TEST: 33N-3N-23A

TITLE	Bracket, HWH Lift Mechanism Cylinder Support		
DWG NO	157066		SHEET 1 OF 1
USAGE	SEE PRINT INDEX		
DRAWN	bseegert	DATE	
CHECKED		DATE

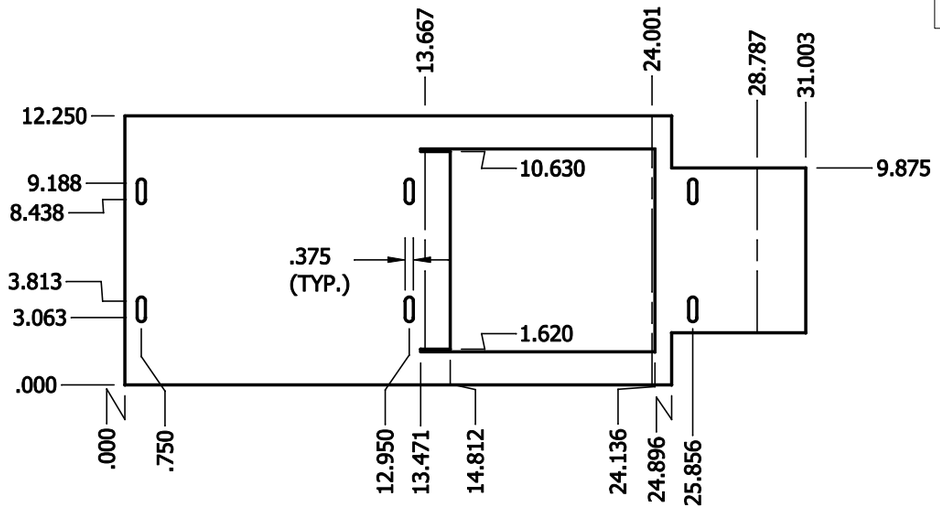
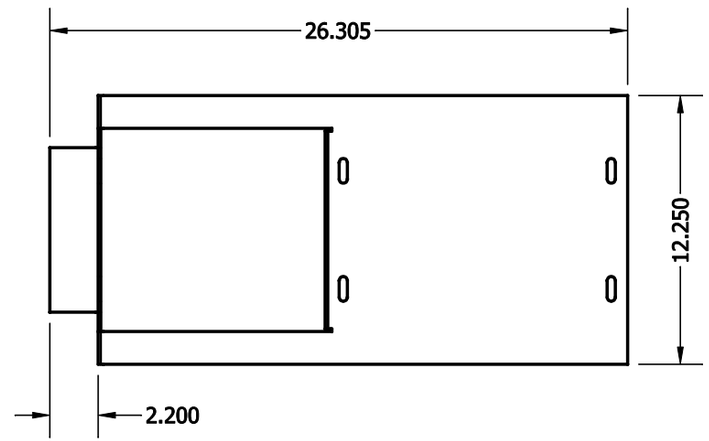
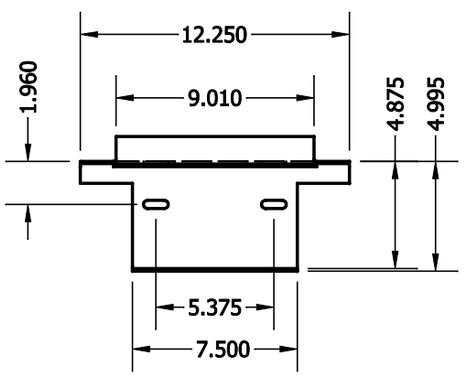
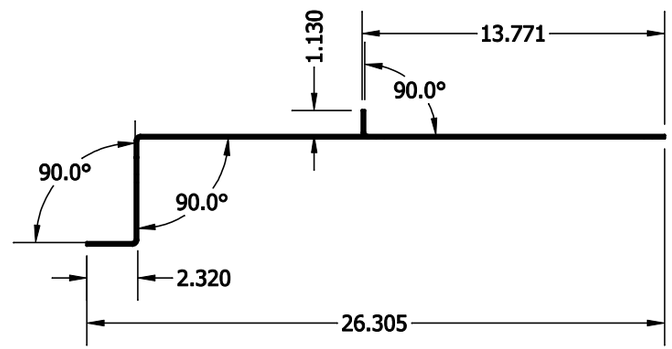
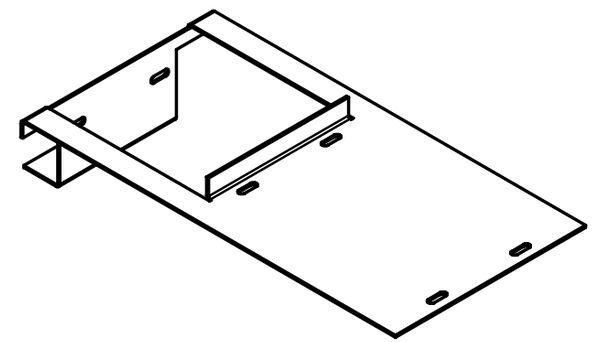
REVISIONS:
- REMOVED 1" LEG AND EXTENDED FRONT OF PART.
- ADDED 1/8" ON BOTTOM LEG. WAS 2.195", NOW 2.32"
- CHANGED THE FRONT WIDTH TO 8 1/4" INSTEAD OF 9 1/4"
- CHANGED THE FRONT WIDTH TO 7 1/2" INSTEAD OF 8 1/4"
- REMOVED REAR CUTOUT
